# Access Compliance Report

## Public Rights-of-Way

### (Curb Ramps)

Intersection ID: 47449	Main Street: MALLARD_LANDING_RD	Cross Street: WOOD_DUCK_CROSSING_DR	Location: SE
ADA ID: A7FF2610B9C7	Ramp Type: PerpDiag	Initial Pass/Fail: Fail	Overall Compliance: No
Severity Score: 12.5			
Codes/Mitigation Info/Possible Solution		Field Measurements/Component Compliance

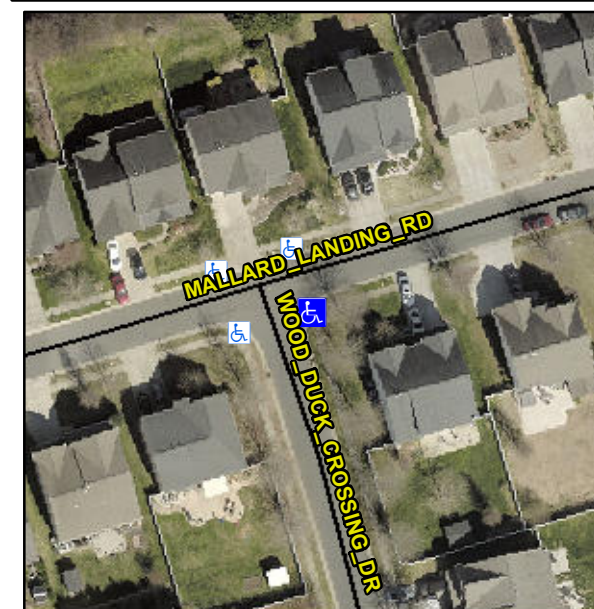
**Not Found, R304.2.2**

Compliance	Description	Data	Compliance	Description	Data
N/A	Ramp Length (in)	49.5	No	Ramp Slope (%)	8.4
Yes	Ramp Width (in)	48.5	Yes	Ramp XSlope (%)	1.6
N/A	Flare Type LT	N/A	N/A	Flare Type RT	N/A
N/A	Flare Slope LT (%)	N/A	N/A	Flare Slope RT (%)	N/A
N/A	Flare Traversable LT?	N/A	N/A	Flare Traversable RT?	N/A
N/A	Landing Length (in)	N/A	N/A	DWS Provided?	N/A
N/A	Landing Width (in)	N/A	N/A	DWS Contrast?	N/A
N/A	Landing Slope (%)	N/A	N/A	DWS Length (in)	N/A
N/A	Landing X Slope (%)	N/A	N/A	DWS Full Width?	N/A
N/A	Landing Curb? (Y/N)	N/A	N/A	DWS Offset (in)	N/A
N/A	Shared Landing?	N/A			
N/A	Gutter Ponding?	N/A	N/A	Gutter Slope (%)	N/A
N/A	Gutter Lip Ht (in)	N/A	N/A	Gutter X Slope (%)	N/A
N/A	Painted X Walk1?	No	N/A	Painted X Walk2?	No
	X Walk 1 Direction	To N		X Walk 2 Direction	To W
N/A	X Walk 1 Width (in)	N/A	N/A	X Walk 2 Width (in)	N/A
	X Walk 1 Slope (%)	3.9		X Walk 2 Slope (%)	4.4
	X Walk 1 X Slope (%)	3.5		X Walk 2 X Slope (%)	1.3

**Remove & Replace Curb Ramp With Two New Directional Ramps or Equivalent.**
